**From:** Mike Gaither  
**To:** [Saxton, John](#)  
**Cc:** [Burrows, Ronald](#)  
**Subject:** [External\_Sender] RE: Three Revised Figures for the Met report  
**Date:** Monday, December 11, 2017 1:40:13 PM  
**Attachments:** [LC Wind Roses POR rev.pdf](#)

**From:** Saxton, John [mailto:John.Saxton@nrc.gov]  
**Sent:** Monday, December 11, 2017 10:22 AM  
**To:** Mike Gaither <mike.gaither@UR-Energy.com>  
**Cc:** Burrows, Ronald <Ronald.Burrows@nrc.gov>  
**Subject:** Three Revised Figures for the Met report

Please revise and resubmit the following three (3) wind roses from the November 11, 2017 report.

**2013**

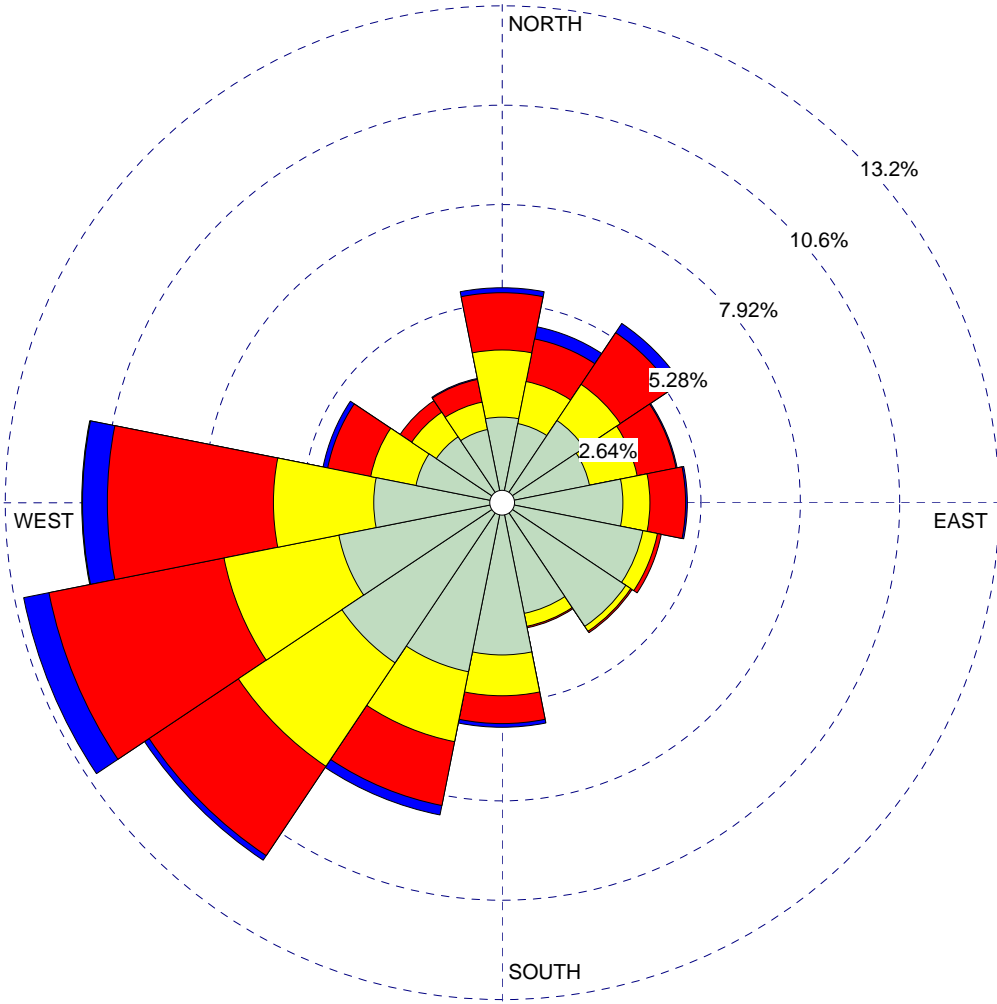
- (1) 2013 - The data period suggests it was 2014 instead of 2013
- (2) 2014 - The data period suggests it was 2013 instead of 2014
- (3) Composite for period of Record (2009-2010, 2012-2014) – The data period suggest that data collected at less than the minimum recovery rate (e.g., 2011, 2015) were included in the wind rose

**Start Date: 1/1/2013 - 00:00**  
**End Date: 12/31/2013 - 23:00**
